RAANS

Airworthiness Directive: 122

Subject: 912/912S Oil Pressure Sender and Oil Pressure Switch

Models Effected: All Models using 912 and 912S Engines

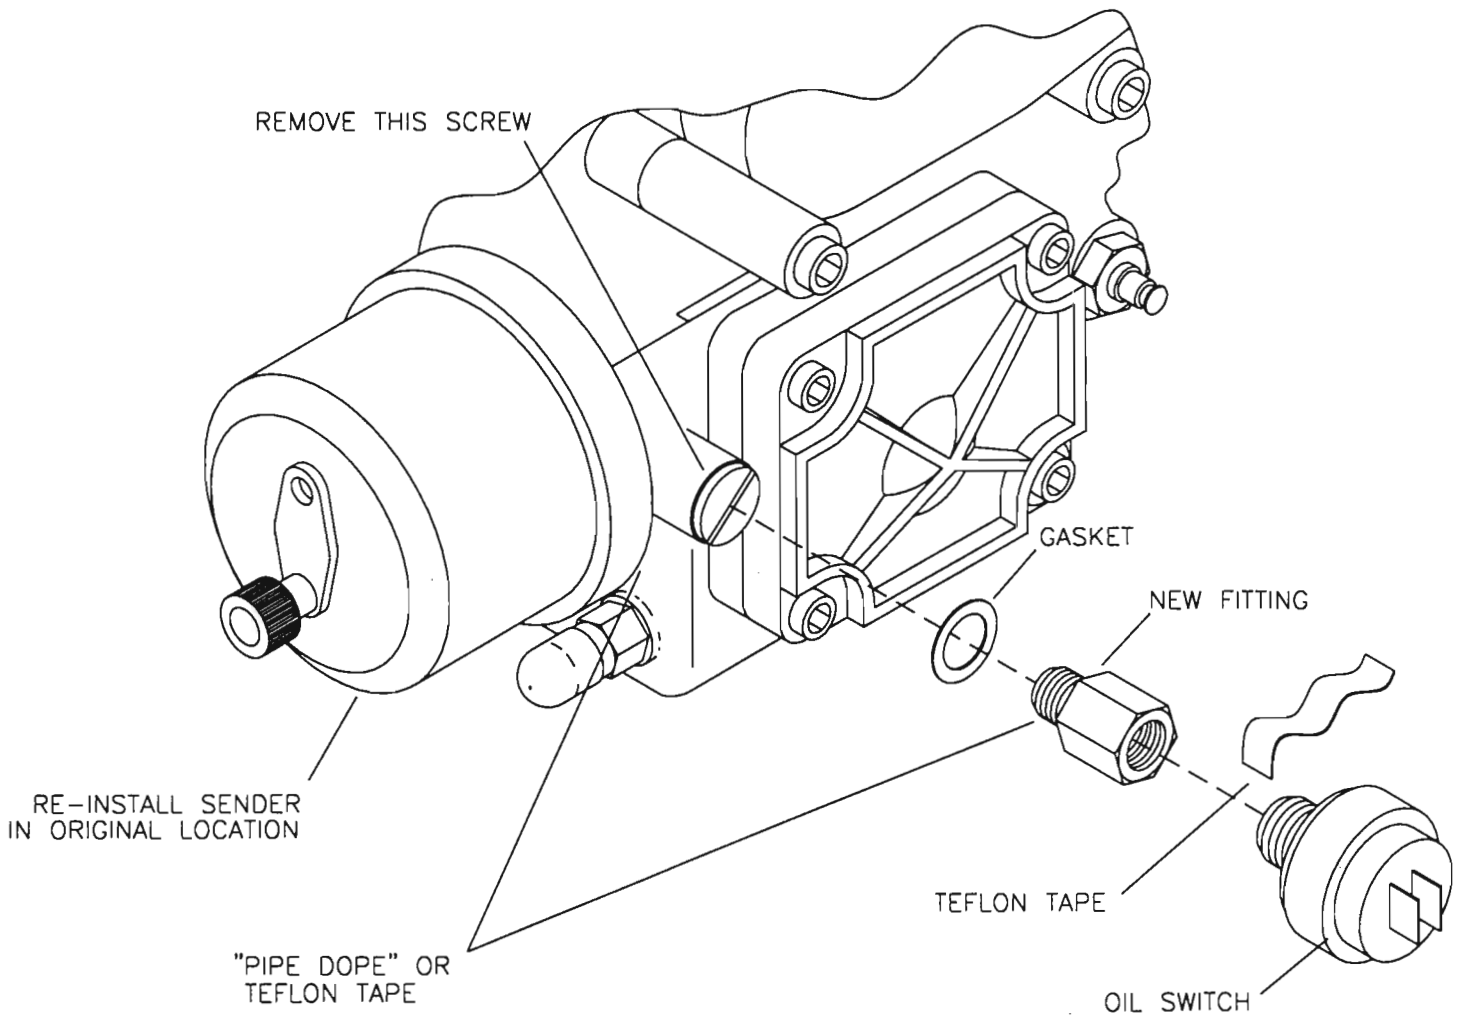
NOTICE: Inspect before your next flight for type of fitting retaining the oil pressure switch and oil pressure sender. If fitting is brass, please replace with new fitting, part number ADAPT1/8-10MM, as per this AD.

Steel fitting **does not** need to be replaced and can be identified by the hex shape between threads, see the attached figure drawings.

"CLOSED NIPPLE"
BRASS, REPLACE

NIPPLE-STEEL, NO
NEED TO REPLACE

1. Remove nipple, brass tee and switch, and sender units.
2. Re-install sender with "pipe dope" or teflon tape.
3. Remove the large flat head screw. **NOTE:** Save gasket under screw head
4. Slip gasket over new fitting and screw on with teflon tape or "pipe dope". Torque to **125 in lbs.**
5. Install oil switch, reconnect wires to both units
